CITY OF AURORA
OHIO
Architectural Board of Review
Work Session Minutes
August 18, 2016

✚ Discussion of Commercial and Residential Guidelines

City of Aurora, Ohio
Architectural Board of Review
Residential Guidelines

Chimneys:

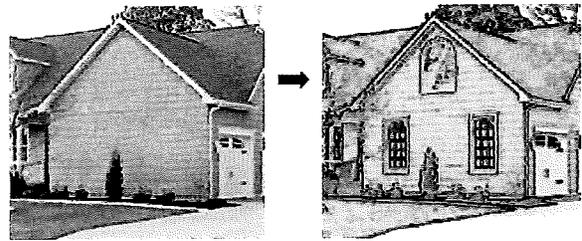
Page 3, Chimneys, the comma after the word vent, will be moved to after the word roof. "Or not visible from the right-of-way" will be added to the last sentence pertaining to exceptions.

Bay Windows (i.e. projecting windows): (we will create a figure for this)

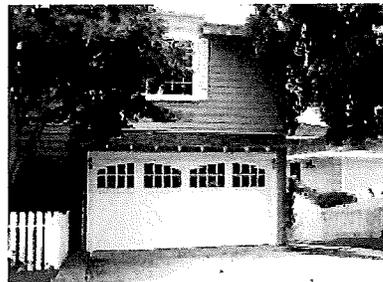
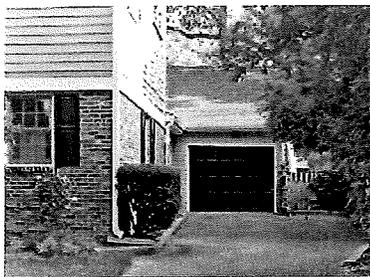
Page 3, Bay Windows will be changed to Projecting Windows. 4'0" will be changed to 36" or less. Window type illustrations will be added. If a window projects 2' or more, it must have the appearance of a solid foundation.
